802.3dj D2.2

Comment Resolution

Common Track

Matt Brown (Alphawave Semi), 802.3dj Chief Editor, Matt Brown (Alphawave Semi), Leon Bruckman (Nvidia), Tom Huber (Nokia), Eugene Opsasnick (Broadcom)

116.3.3.4.1 Semantics of the service primitive

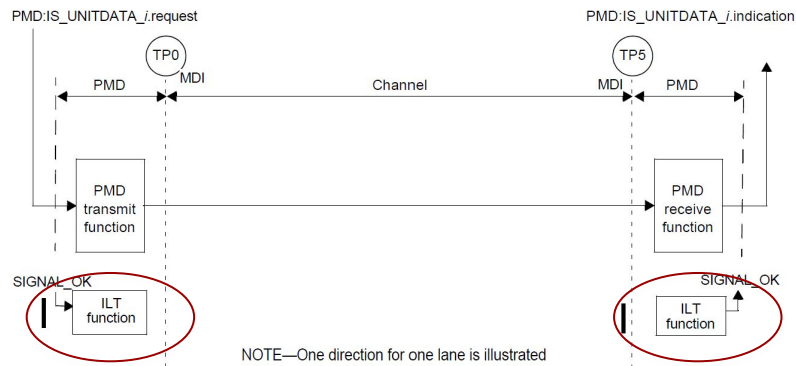
Change:

"for Physical Layer implementations that use the ILT function"

“for service interfaces between interfaces that use the RTS function (see 178B.x)”
